SERVICE BULLETIN #20121106

SUBJECT: "Reserve Staging Loop" with support washer. We (manufacturer) require the washer be removed. At the next scheduled repack cycle, remove the washer from the bungee staging loop and tie a double over-hand knot as instructed below and reinstall.

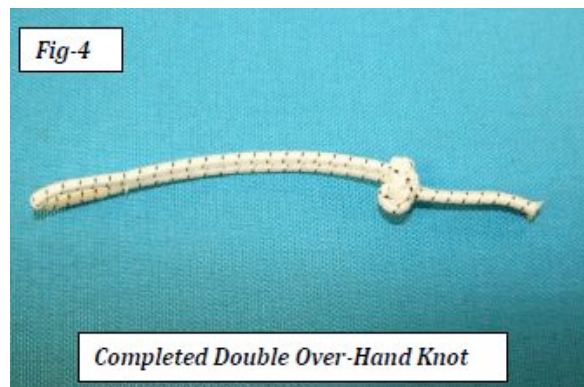
SERVICE BULLETIN: At the next scheduled inspection/repack cycle remove the support washer from the "Reserve Staging Loop." (Fig-1) Inspect the internal and external condition of the staging loop and replace it if any damage is found. Tie a "Double Over-Hand Knot" at the prescribed location. The staging loop length should be 1-inch (25mm) shorter than the reserve closing loop. Mark the loop at the desired length. Fig-2 shows a single over-hand knot. Fig-3 shows the loop end passing one more time through to create the double
